**RE: PERMISSION FOR A LARGE-SCALE RESIDENTIAL DEVELOPMENT (LRD) AT THIS SITE AT POPES HILL, POPES ROAD, BLACKPOOL, CORK CITY. THE PROPOSED DEVELOPMENT WILL CONSIST OF A LARGE-SCALE RESIDENTIAL DEVELOPMENT (LRD) COMPRISING OF THE FOLLOWING: (1) THE DEMOLITION OF A TERRACE OF 4NO. EXISTING DWELLINGS, 3NO. OF WHICH ARE DERELICT, AND ANCILLARY SHEDS AND THEIR REPLACEMENT WITH 1NO. SINGLE-STOREY 3-BED DETACHED BUNGALOW (116SQM.) ACCESSED VIA A MODIFIED PRIVATE DRIVEWAY; (2) THE CONSTRUCTION OF 103NO. DWELLINGS (10980.6SQM.) (18NO. 1-BEDS, 9NO. 2-BEDS, 68NO. 3-BEDS, AND 8NO. 4-BEDS) OF BETWEEN 2-4 STOREYS IN HEIGHT, TO INCLUDE 50NO. TOWNHOUSES (3NO. 2-BED UNITS; 39NO. 3-BED UNITS AND 8NO. 4-BED UNITS); AND 53NO. DUPLEX APARTMENTS (18NO. 1-BED APARTMENTS, 6NO. 2-BED APARTMENTS, AND 29NO. 3-BED APARTMENTS); (3) THE PROPOSED DEVELOPMENT WILL ALSO INCLUDE A GROUND FLOOR CRÈCHE (217.4SQM.) WITH REAR GARDEN AND FRONT SET DOWN AREA. (4) THE PROPOSED DEVELOPMENT WILL ALSO INCLUDE 104NO. CAR PARKING SPACES, 128NO. CYCLE SPACES, INTERNAL ROADS AND PATHWAYS, INCLUDING INTERNAL TRAFFIC CALMING MEASURES AND PEDESTRIAN CROSSINGS; THE PROVISION OF PRIVATE, COMMUNAL AND PUBLIC OPEN SPACE, INCLUDING ALL

**Figure 1: Proposed Development Site relative to Maps 01, 02, and 03 of Volume 2 of the Plan**

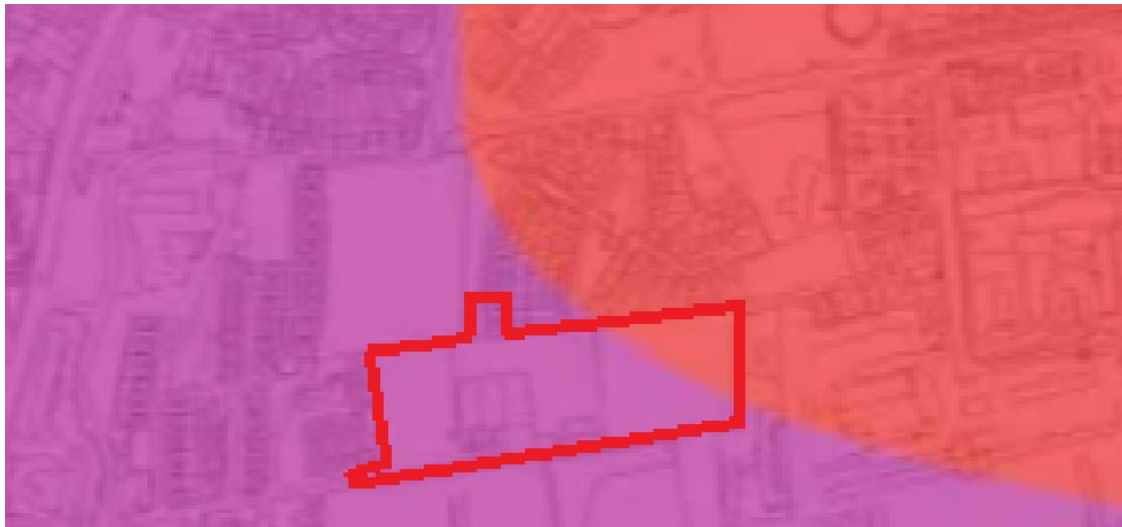
*Recent ACP decisions have, in May 2026, applied a strict interpretation of requirements as set out in the Cork City Development Plan 2022-2028 (CCDP) and the Sustainable Residential Development and Compact Settlements - Guidelines for Planning Authorities 2024. In particular, where proposals were deemed not to accord with the required density or unit mix. The following further information is required to aid in the assessment of the proposed development in this specific context:*

- a. *Table 11.2 of the CCDP shows that a density of 50-100 units applies. Table 3.1, City – Urban Neighbourhoods, of the Guidelines indicates that a range of 50-250 applies.*

*There may be justification, on the subject site, for a density that is outside of the range of density required in the CCDP and Guidelines. The rationale for the proposed density set out in the application documentation however identifies the wrong range as being applicable to the site. Additionally, the justification for the density is not considered robust.*

*Please submit a corrected and updated rationale / justification to aid in the assessment of this application.*

- In addition, and as illustrated in Figure 1 below, we note that in Maps 01, 02 and 03 of Volume 2 of the Plan that the site straddles the Fringe/Corridor/Centre and Inner Urban Suburbs areas, where an average target density of 45-100 units/ha is supported. This must be taken into account in defining the appropriate density for the site. It is also considered that the targets set out in the Plan could be considered to constitute a recommended range as opposed to a definitive limitation. The proposed density of 43.3ha is very close to the recommended range.

- We also note that the RFI states that *there may be justification, on the subject site, for a density that is outside of the range of density required in in the CCDP and Guidelines*. Implicit in this is an understanding that, given its characteristics, there is scope to consider an appropriate density that this location. It is also considered that the proposed density is only marginally below the recommended range.

Figure 2: Revised westernmost pedestrian access to Glentrasna Crescent

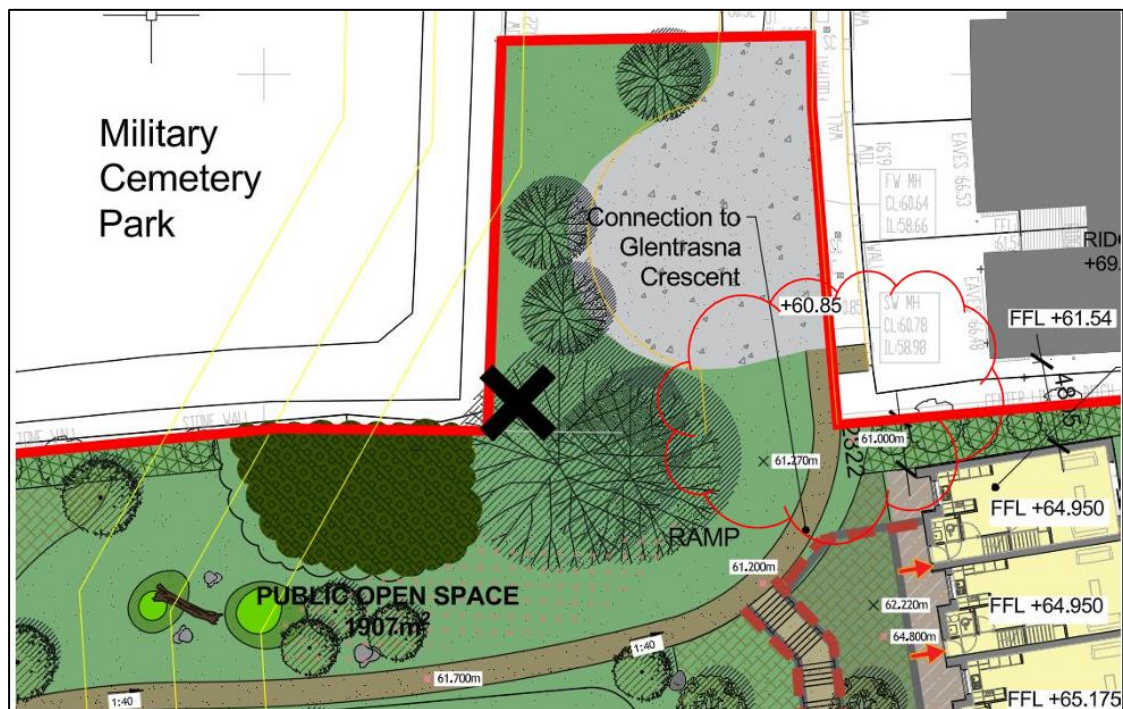
*A review of the site layout plan shows that there is a long narrow 'strip' of land between the subject site and the Glentrasna estate. It is not taken in charge, and, as it has not been identified with a blue line on the Site Location Map. The red line does not extend over this 'strip' where proposed pedestrian accesses are located.*

- In order to demonstrate compliance with the mapped objective for a Walkway & Cycleway through the site, and provide for permeability, please submit detailed plans and documentation to demonstrate exactly how the westernmost of these two proposed access points will be achieved – noting that the wall through which access must be made is outside of the redline boundary where the path is currently proposed. Any plans submitted shall show the existing boundary wall and where the opening will be made.*
- Please submit proposals for how the remaining strip between the subject site and Glentrasna estate will be accessed and managed.*

The development now proposes a single pedestrian/cycle connection at the western side of the site in accordance with the permeability objective for the site as set out in the Plan.

The westernmost pedestrian access to the site has been revised to be fully contained within the red line boundary and for which the applicant has the relevant consent, as originally submitted. This is illustrated on the revised Site Layout Plan (**P23-288C-RAU-XX-00-DR-A-1000**) and Landscape Masterplan (**24184-2-101**) drawings enclosed herein.

Further to this, and having regard to the extent of submissions on the matter, as well as the fact that strip of land to the north is outside the control of the applicant, the easternmost access to Glentrasna is now proposed to be omitted.
